2015-08-04 Various Aircraft: Amendment 39-18140; Docket No. FAA-2014-1083; Directorate Identifier 2014-CE-036-AD.

Procedures and Requirements for Ultrasonic Inspection of Piper Wing Lift Struts

Airworthiness Directives; Various Aircraft Equipped With Wing Lift Struts

ACTION: Final rule.

Figure 1

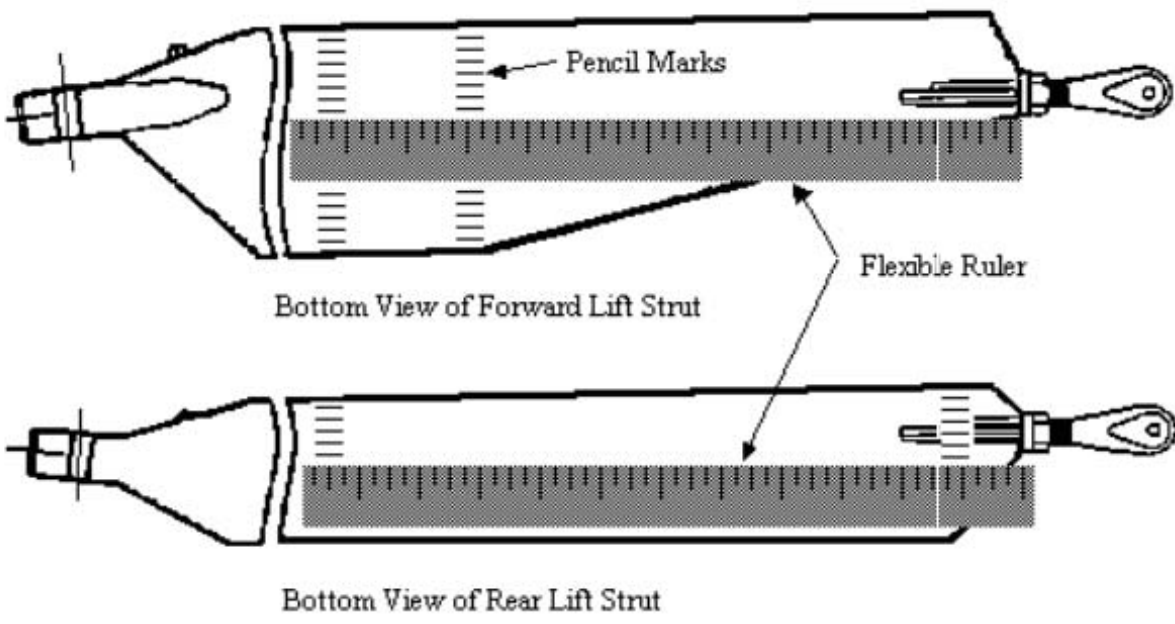
2. Using a flexible ruler, draw a 1/4-inch grid on the surface of the first 11 inches from the lower end of the strut as shown in Piper MSB No. 528D, dated October 19, 1990, or Piper MSB No. 910A, dated October 10, 1989, as applicable. This can be done using a soft (#2) pencil and should be done on both faces of the strut. As an alternative to drawing a complete grid, make two rows of marks spaced every 1/4-inch across the width of the strut. One row of marks should be about 11 inches from the lower end of the strut, and the second row should be several inches away where the strut starts to narrow. Lay the flexible ruler between respective tick marks of the two rows and use tape or a rubber band to keep the ruler in place. See Figure 1.
